P 536001

## Septic Repair

**ON-SITE SEWAGE DISPOSAL SYSTEM  
HOWARD COUNTY HEALTH DEPARTMENT  
BUREAU OF ENVIRONMENTAL HEALTH**

ADDRESS: 13734 Briaridge Court PROPERTY OWNER: Jack Burke

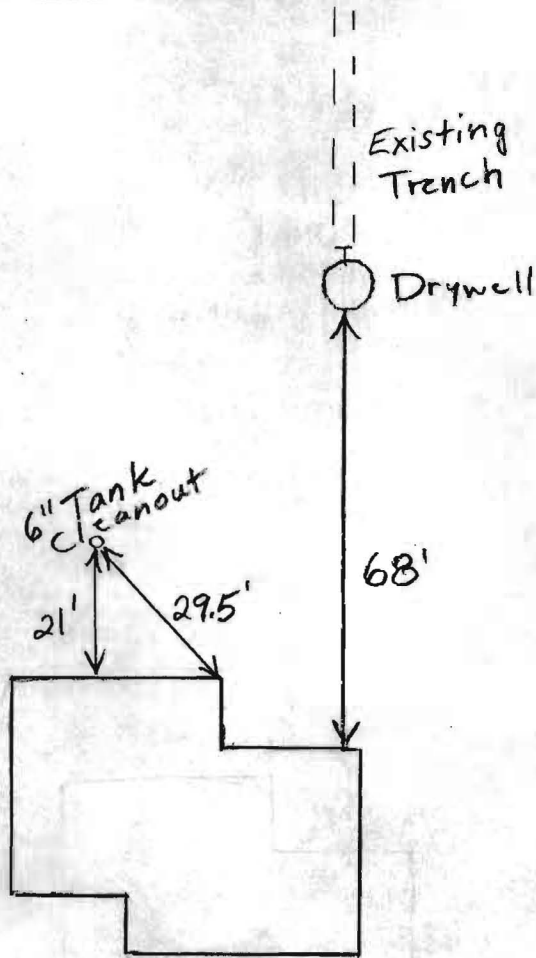
10/21/2011 Drywell cover collapsed. Drywell full. Trench of drywell is dry. Pump out and clean out drywell. Fill drywell with gravel and add a 6" piece of perforated pipe extending from bottom of drywell to grade. Check that existing trench is O.K. If O.K. connect trench to drywell. Also, cover drywell with fabric. (BB)

11/8/2011 Drywell pumped out and filled with gravel. Everything covered except for part of drywell when I arrived. Installer said that existing trench looked O.K. alright to finish backfilling. (BB)
